INDESIT company

BAN13S

F034688

51520g0 Exploded views

N1030093fig1

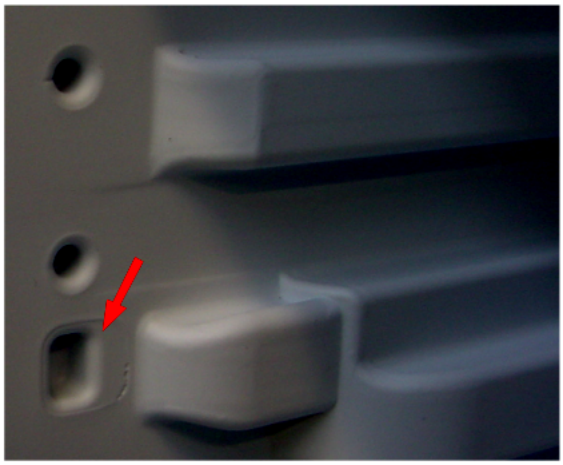
n1030093: New fixing of evaporator on static fridge-freezers (05 range) 60 cm,Melano

From August 05 (serial no. 50802.0001) the freezer evaporator is secured to the cabinet by a plastic profile.
The cabinet walls have been modified to create locations to house the profile, which is installed on the front of each evaporator plate (see photo N1030093fig1- fig2 - fig3)
The profile cannot be fitted on premodification appliances, so technical personnel must continue to fit the rh and lh supports on these models (see photo N1030093fig4)

New parts
C00141135 = WHITE PROFILE L=443.5 MM

Parts replaced
C00075596 = EVAPORATOR RH SUPPORT
C00075597 = EVAPORATOR LH SUPPORT

N1030093fig1

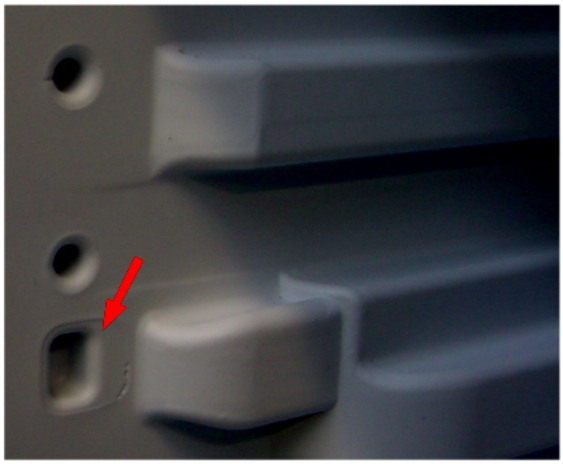
n1030094: New fixing of evaporator on static fridge-freezers (05 range) 60 cm, Lodowek

From August 05 (serial no. 50820.0001) the freezer evaporator is secured to the cabinet by a plastic profile.
The cabinet walls have been modified to create locations to house the profile, which is installed on the front of each evaporator

plate (see photo N1030093fig1- fig2 - fig3)
The profile cannot be fitted on premodification appliances, so technical personnel must continue to fit the rh and lh supports on these models (see photo N1030093fig4)

New parts
C00141135 = WHITE PROFILE L=443.5 MM

Parts replaced
C00075596 = EVAPORATOR RH SUPPORT
C00075597 = EVAPORATOR LH SUPPORT
